Health Department, Elkhart
608 Oakland Avenue
Elkhart, Indiana 46516

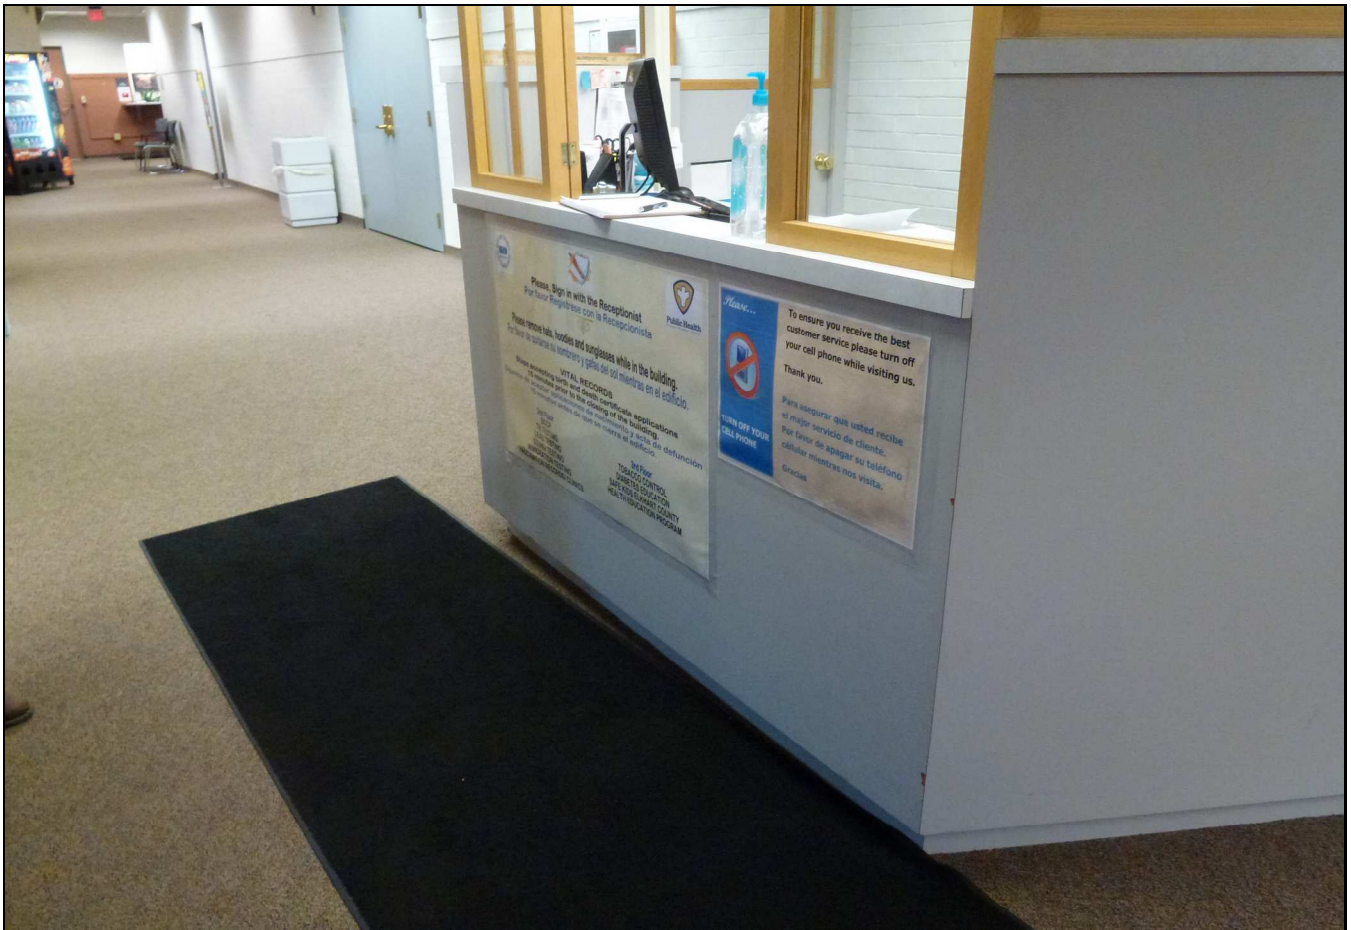
1. Parking	1, 2	No "Van Accessible" sign at van accessible parking space. No enforcement procedure for accessible parking	4.6.4	ADAAG requires accessible parking spaces to be located in each parking lot. Accessible parking spaces are required to have upright signage that includes the symbol of a accessibility and van accessible signage where required. Add one "Van Accessible" sign. Enforce parking regulations.	L: Space is adequate for vans, just no sign posted.	\$50	Elkhart County General Fund	Van accessible sign installed		Jul-14

2. Entrance	3	Rugs at entrance are not secure to ground and may cause tripping hazard	4.5.3	ADAAG requires all carpet and rug edges to be securely fastened to the ground. Replace rugs with edges that are fastened or stick to the floor to minimize tripping hazard.	L: Minimal trip hazard is present.	\$100	Elkhart County General Fund	Rugs removed		Jul-15

3. Signage for goods and services, entire building	4, 5	Signs are mounted too high and some do not contain Grade II Braille	4.30	ADAAG requires signage to be mounted 60" from the floor, on the wall adjacent to latch side of door, to have raised characters and Braille text. Lower signage and add Grade II Braille text.	L: Signs are legible and provide direction.	\$4,000	Elkhart County General Fund

4. Various Service Counters	3	Most service counters exceed the maximum height. The average counter top is 40" high. (4 counters)	7.2	ADAAG requires sale and service counters to have a maximum height of 36" above the finished floor. Lower portion of counter or provide auxiliary counter at 36" height.	M: Majority of customers use a counter in this building. Employee can walk around counter to communicate.	\$2,000	Elkhart County General Fund
